River Quest Phase 3, KPB File 2024-013
 Edge Survey & Design LLC / Nash
 Location: Porter Rd., Brooklyn Ave. & Caden Cir.
 Kalifornsky Area

ITEM #6 - PRELIMINARY PLAT RIVER QUEST PHASE 3

KPB File No.	2024-013
Plat Committee Meeting:	February 26, 2024
Applicant / Owner:	Leland Corporation of Boise Idaho
Surveyor:	Mark Aimonetti and Jason Young / Edge Survey and Design LLC
General Location:	Porter Rd, Brooklyn Ave

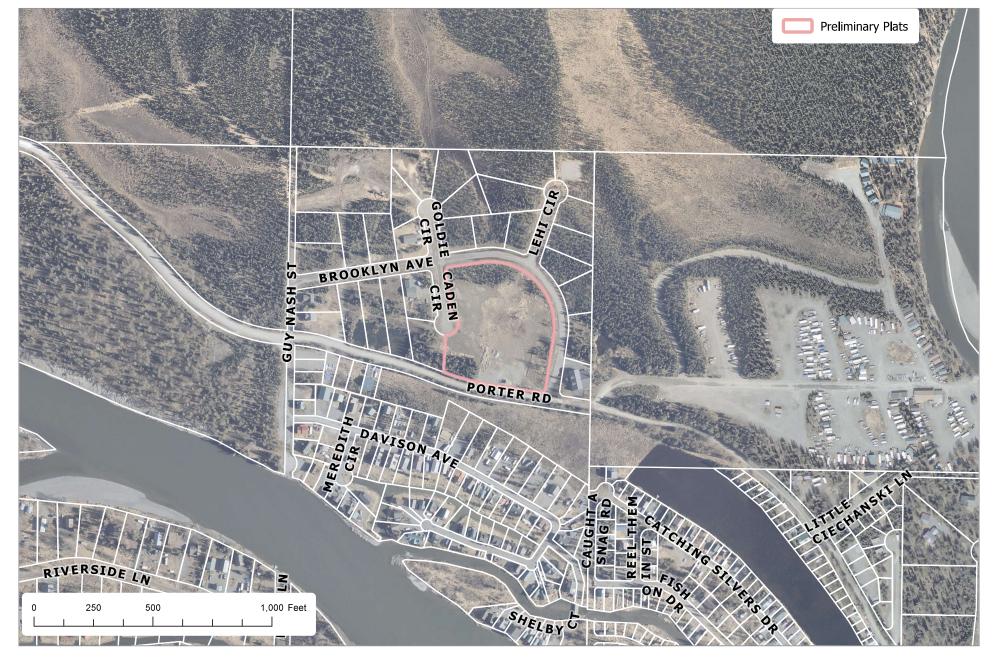
The terrain of the plat is flat with a low spot in the back of the lots. Wetlands are not identified on the plat though. The River Center review did identify plat as being in a FEMA FIRM flood hazard area and the proper flood hazard note is shown at plat note #11. Flood Zone A4 need to be added to plat note #11 as the River Center review indicated that zone to be included on the plat. Zone A4 should also be added to the drawing.

HEA has noted in their reply that plat note #7 does not affect this plat and can be removed. Their reply has also crossed out plat note #8, so it too can be removed. The comment is in the packet

- Add to legal description in title block, Block 2
- Correct spelling of Leland Corporation in both the title block and Certificate of Ownership and Dedication.
- Correct spelling of Boise in the address in both the title block and Certificate of Ownership and Dedication.
- D. A vicinity map, drawn to scale showing location of proposed subdivision, north arrow if different from plat orientation, township and range, section lines, roads, political boundaries, and prominent natural and manmade features, such as shorelines or streams;

Reduce scale and make area around site more readable.

- The borough will not enforce private covenants, easements, or deed restrictions per KPB 20.60.170.
- Plat note #5 needs the date corrected to July 10, 1997.
- Plat note #6 add an "s," to the end of Communication to match the certificate to plat.
- Plat note #11 needs to have the zone of A4 added to it per the River Center review.

Change member name to Robert Nash, to match the entity details as listed as the registered agent with the State of Alaska.
